Ref: 04257

19 July 2017

PARK BEACH RESIDENCES
DEVELOPMENT APPLICATION 0902/17 DA
AMENDMENT TO DEVELOPMENT APPLICATION

This letter is a request by the applicant to amend the above development application prior to determination of the application. This letter also summarises responses to 'stop the clock' requests for information issued by Council, and attaches amended information submitted by the applicant.

Drawing
BUILDING A, B, C & D - ILU
GROUND FLOOR PLAN - CARPARK

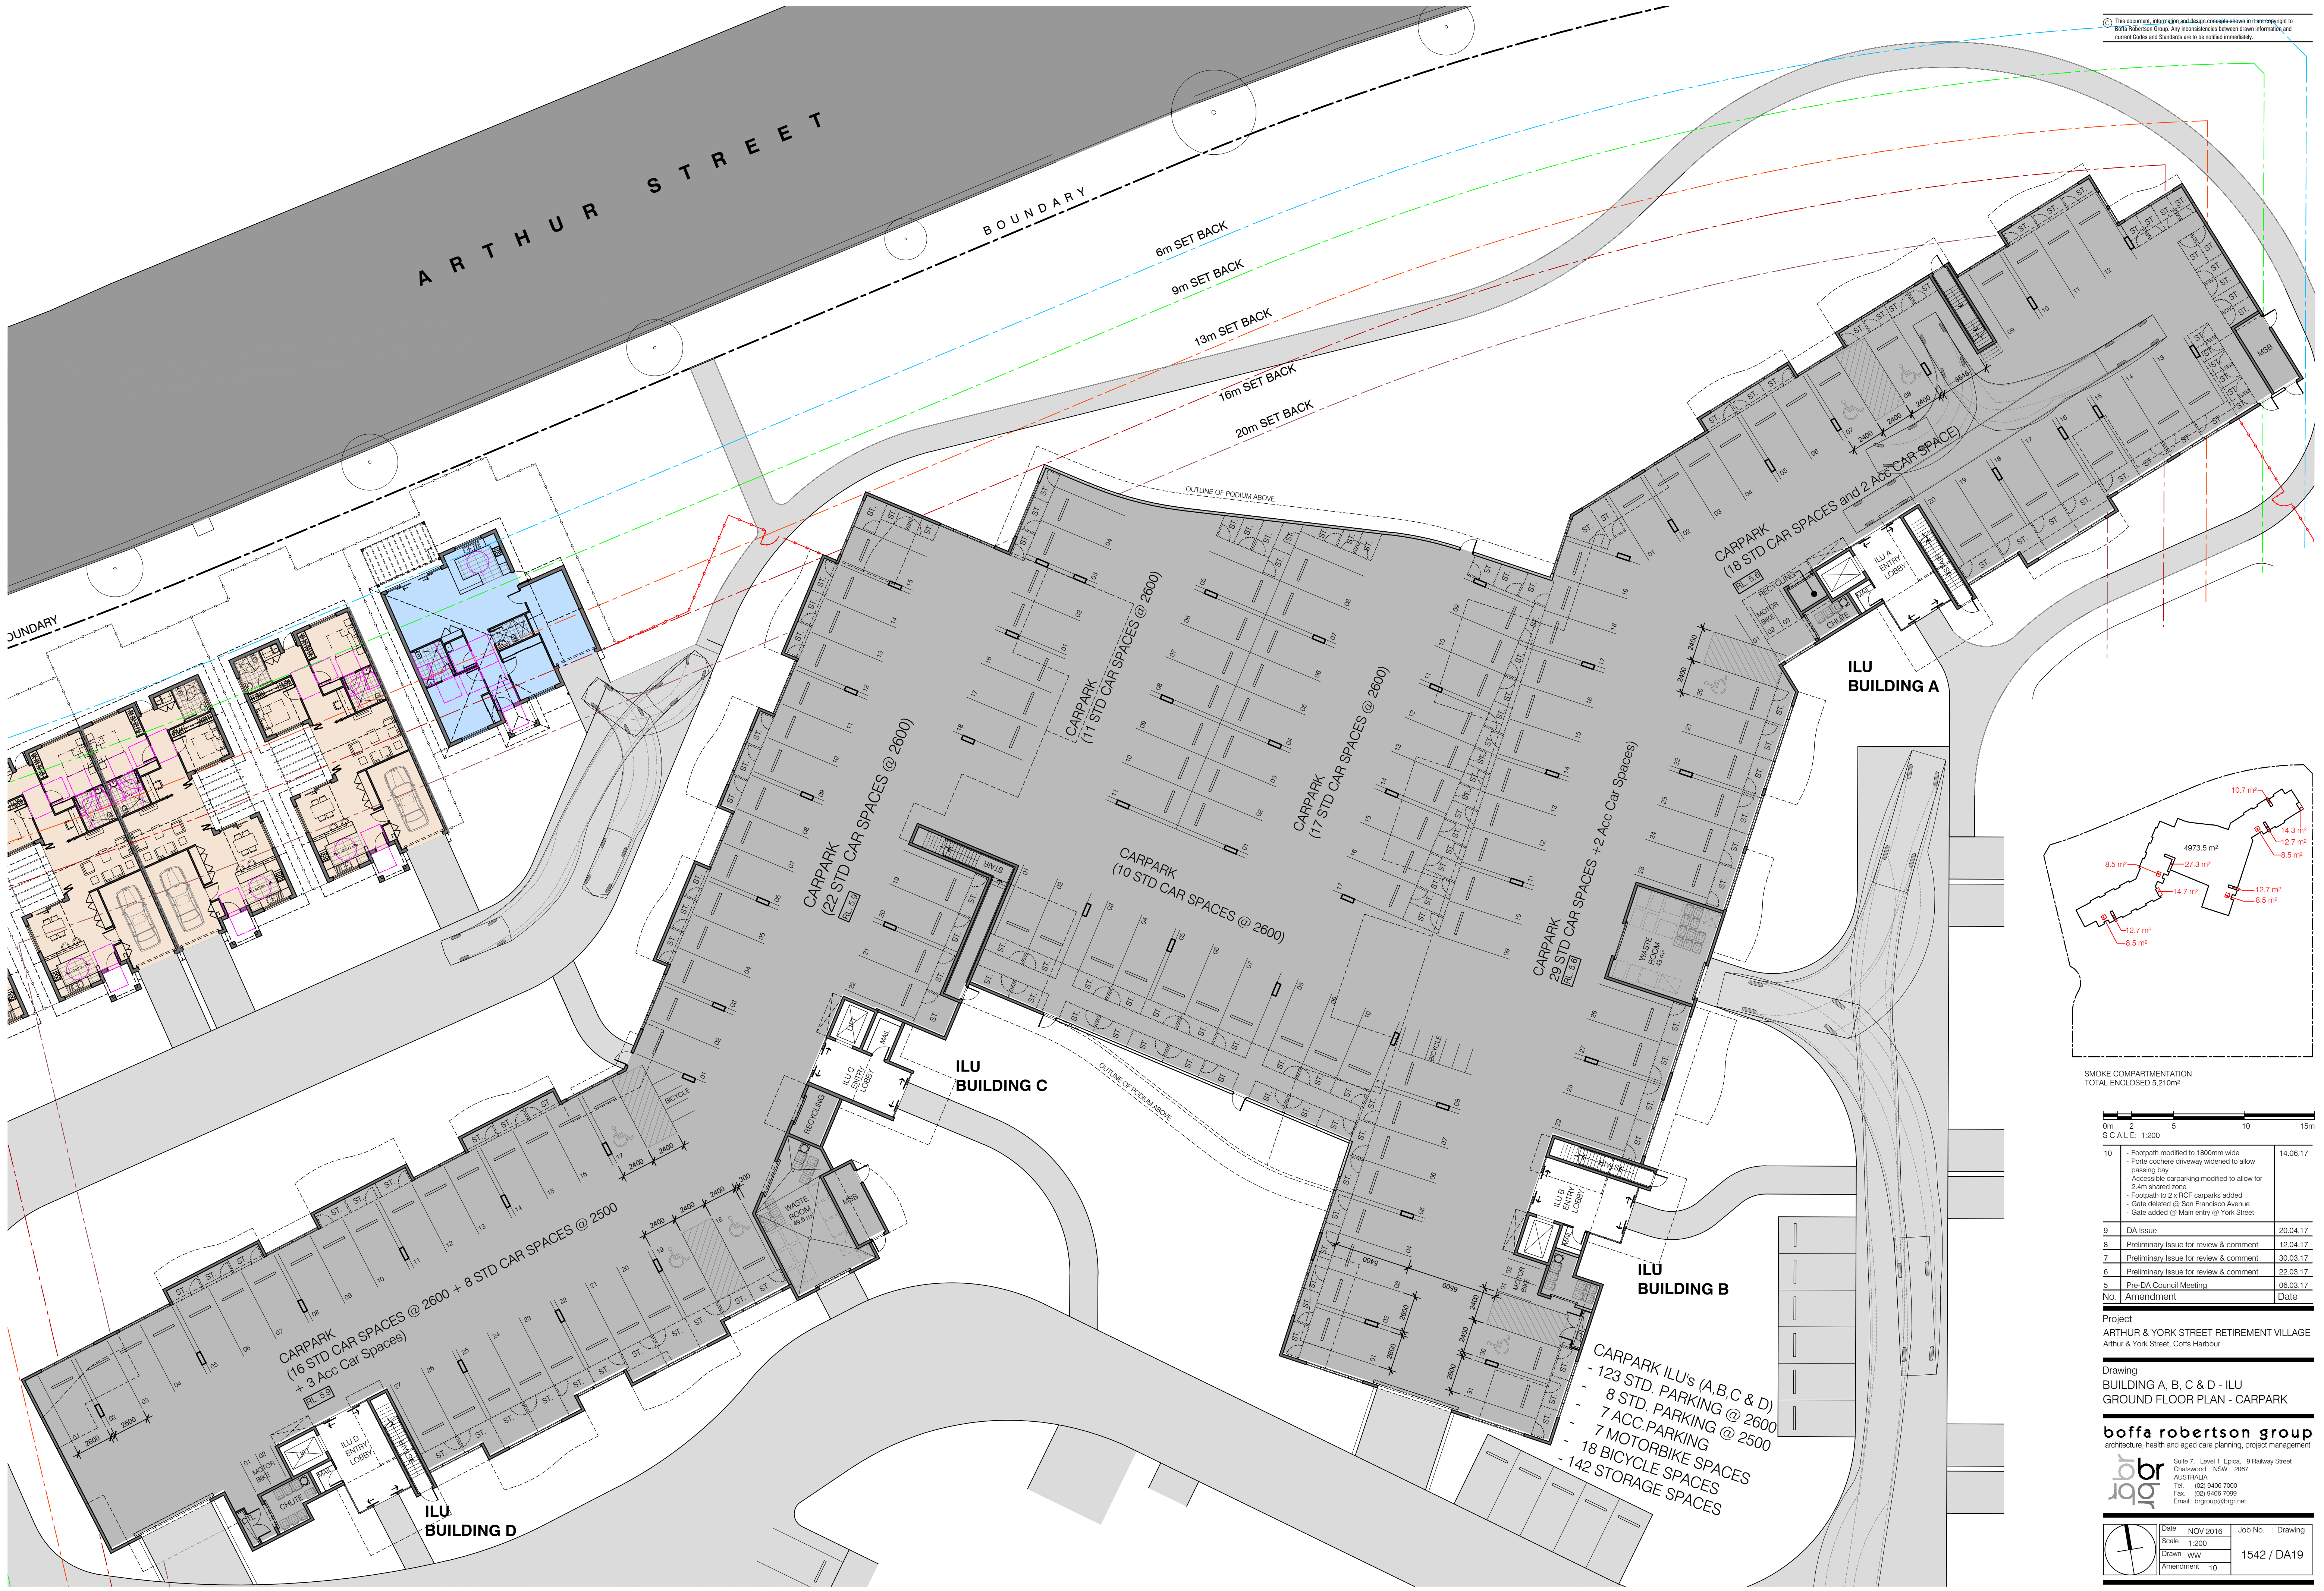
Council commented upon parking matters in its email dated 5 June 2017. Council marked up a plan with comments for the applicant to address. These matters were investigated over a period of time, and the applicants responses are the following documents;

10	- Footpath modified to 1800mm width - Portico cochen driveway widened to allow passing bay - Accessible carparking modified to allow for 2.4m shared zone - Footpath to 2 x PCF carparks added - Gate deleted @ San Francisco Avenue - Gate added @ Main entry @ York Street	14.06.17
9	DA Issue	20.04.17
8	Preliminary Issue for review & comment	12.04.17
7	Preliminary Issue for review & comment	30.03.17
6	Preliminary Issue for review & comment	22.03.17
5	Pre-DA Council Meeting	06.03.17
No.	Amendment	Date

- Amended plan have been produced to address the comments made by Council and show compliant accessible parking, internal turning arrangements, swept path diagrams.

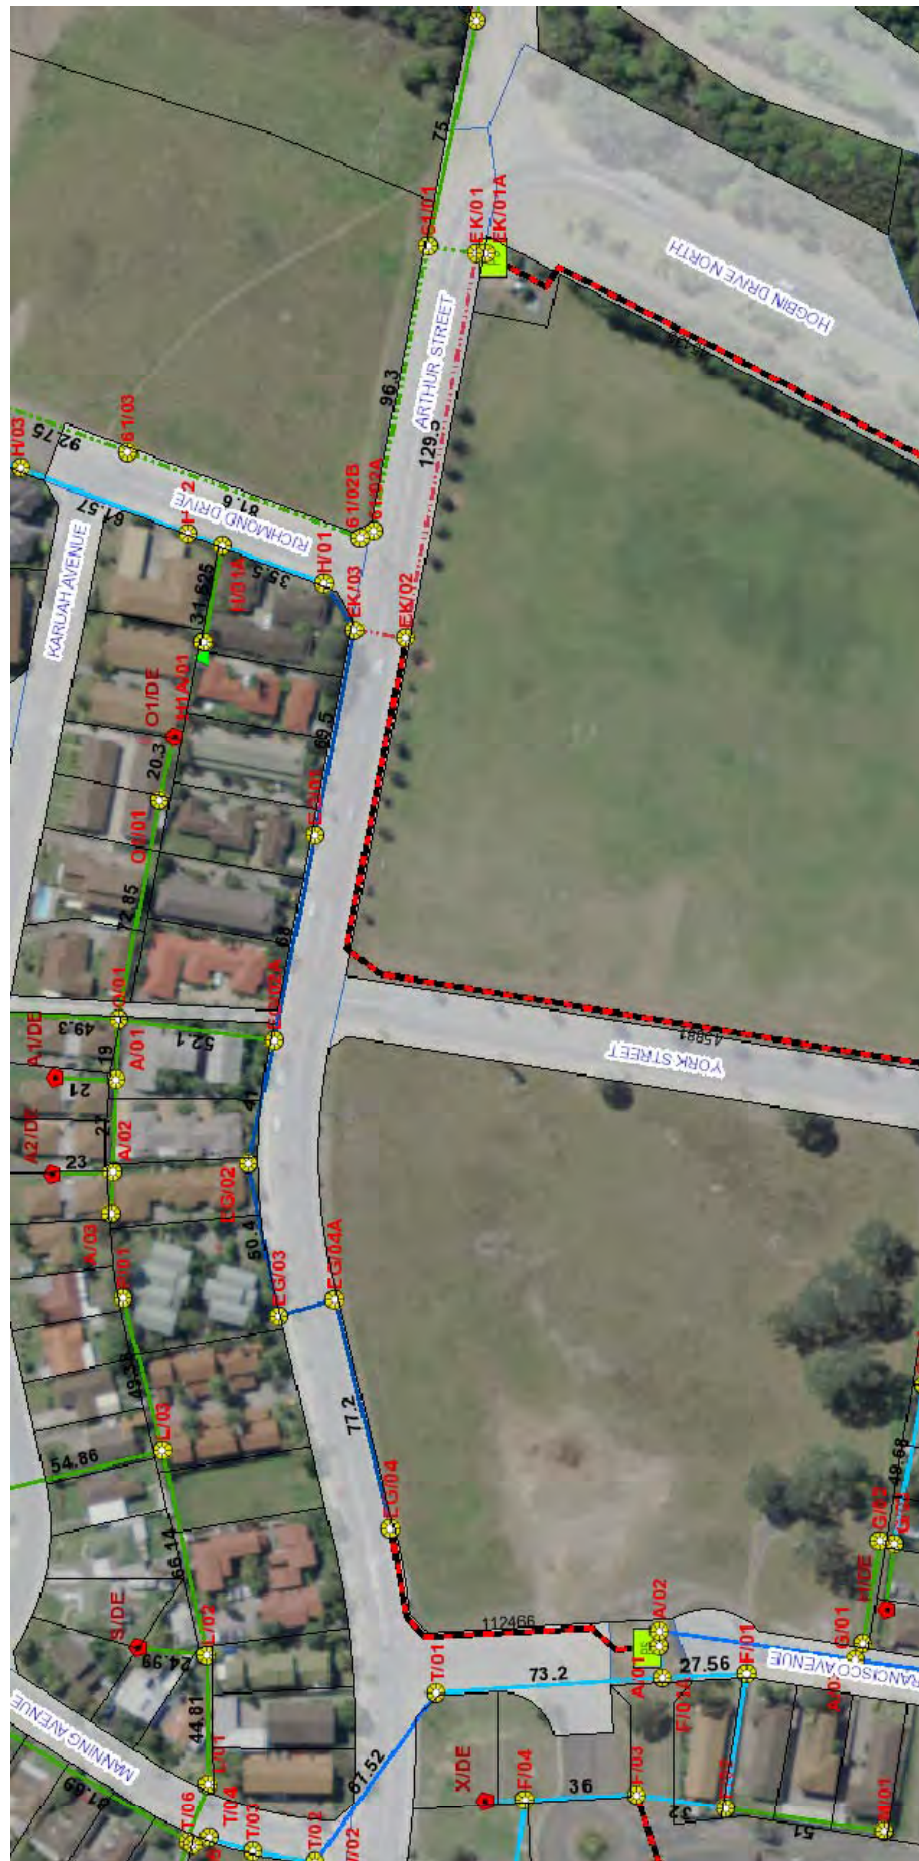
Council requested correction of an asset label on a proposed connection, and reflection of additional sewer loads in a report. The applicants response are the following documents;

We have investigated this further and propose an alternative solution. We propose to connect to a SMH near the SPS1017A such as SMH A/02 on the attached plan, which is expected to be deep enough to adequately service the entire property by gravity. We advise:

- Plan 04257-C07 revision P2
- Amended report 04257 2017-02-14 rev A sewerage
- Amended statement of environmental effects section 5.5
